STAFF REPORT
(Preliminary Plat)

CASE NUMBER: S/D 95-79 THE MANHATTAN ADDITION
OWNER/APPLICANT: Harry B. Brown, Jr. Etal, 800 N. Dublin, Wichita, Ks 67206
CONTRACT PURCHASER: George Sherman, 8609 Stoneridge, Wichita, KS 67206
ENGINEER/SURVEYOR: P.E.C., P.A., c/o Gary Wiley, 303 S. Topeka, Wichita, KS 67202
LOCATION: North of 21st Street North and east of Greenwich Road
SITE SIZE: 20 Acres

STAFF REPORT
(Final Plat, Preliminary Plat Approved 12/7/95)

VICINITY MAP:

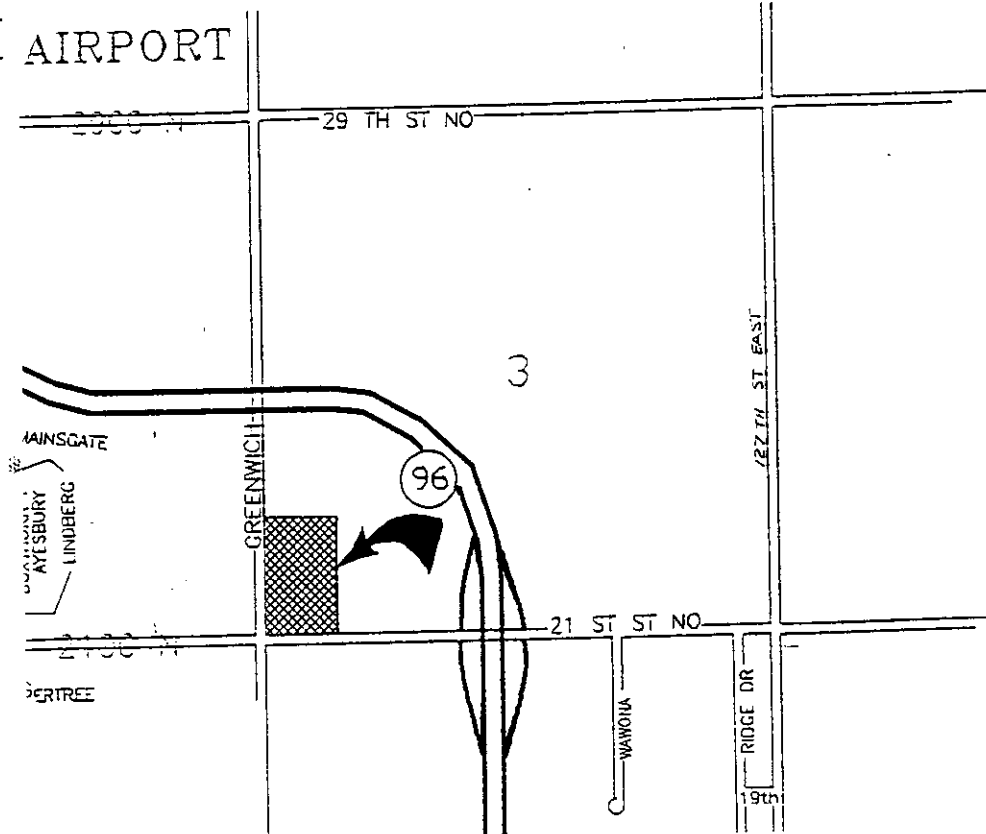
- A. The applicant shall guarantee the extension of municipal water to this site. As necessary, such guarantee(s) shall provide for any needed off-site extensions. City Engineering and/or the Water Department representative need to indicate requirements for water improvements both off-site and adjacent to this site (i.e., along 21st and/or Greenwich).

- B. The applicant shall guarantee the extension of municipal sanitary sewer to serve this site. This guarantee shall provide for any needed off-site extensions and/or related improvements such as pump stations. Any needed off-site easements shall also be obtained by the applicant and submitted to Planning for recording if within Wichita or to County Engineering if involving County properties.

- C. While various improvements may be under consideration for Greenwich and 21st Street, County Engineering needs to indicate requirements for additional traffic type improvements to serve this site; especially in regard to the proposed expansion of commercial uses in this area. As indicated previously, off-site improvements are to be guaranteed by the subdivider. Such improvements may include but are not limited to; accel-decel lanes, left-turn improvements, signalization, and so forth.

- D. The applicant shall guarantee those portions of major entrances located within areas of street right-of-way.
- E. The applicant shall guarantee any drainage improvements required by the platting of this property.

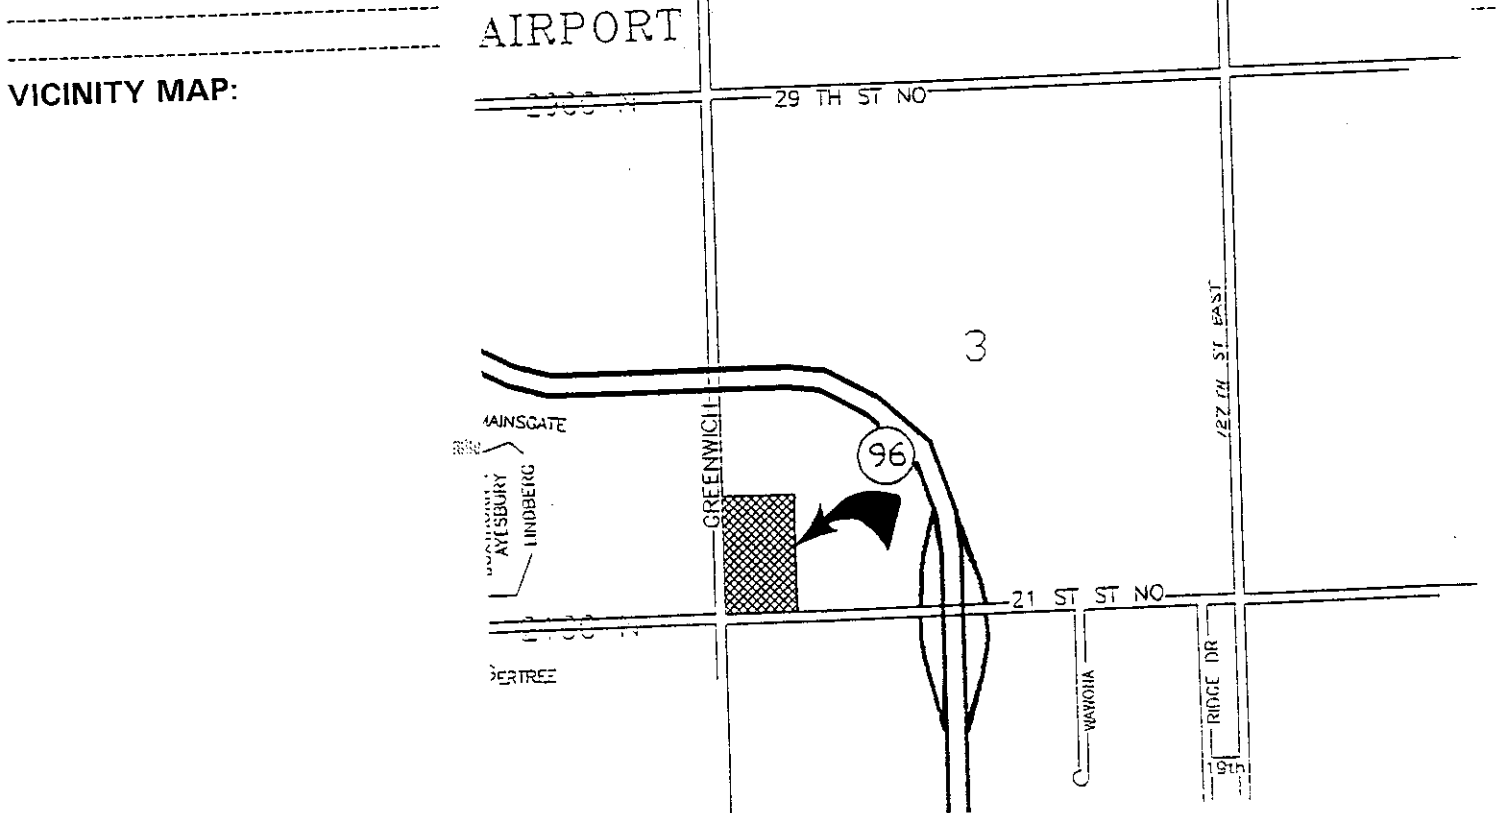
- A. The applicant shall guarantee the extension of municipal water to this site. As necessary, such guarantee(s) shall provide for any needed off-site extensions. City Engineering has indicated that the City of Wichita currently has a City CIP project to extend water along 21st Street all the way to 127th Street. The applicant shall guarantee the extension of water along Greenwich and/or participate in the City CIP project for the extension of a water line. Both City Engineering and the Water Department representative will need to specifically indicate requirements for water improvements both off-site and adjacent to this site (i.e., along 21st and/or Greenwich).

- B. The applicant shall guarantee the extension of municipal sanitary sewer to serve this site. This guarantee shall provide for any needed off-site extensions and/or related improvements such as pump stations. Any needed off-site easements shall also be obtained by the applicant and submitted to Planning for recording if within Wichita or to County Engineering if involving County properties.

- C. While various improvements may be under consideration for Greenwich and 21st Street, County Engineering indicated the intersection of 21st and Greenwich Road will require full signalization (red, yellow, and green lights) rather than a yellow light on 21st Street and a red light on Greenwich Road. As indicated previously, off-site improvements are to be guaranteed by the subdivider. Such improvements may include but are not limited to; accel-decel lanes, left-turn improvements, signalization, and so forth. Guarantees would be expected for continuous accel/decel lanes from/to major openings and around the intersections, plus left-turn lanes extended to major openings.

- property. The County Engineer indicated that for drainage purposes, there should be a parking lot detention facility which is not indicated on the drainage concept. It should be included on the final drainage plan.

- F. In regard to access controls, both Traffic Engineering and County Engineering need to comment on the number of requested openings, in particular the four (4) openings to 21st Street would seem greater than necessary and should be reduced to three (3).
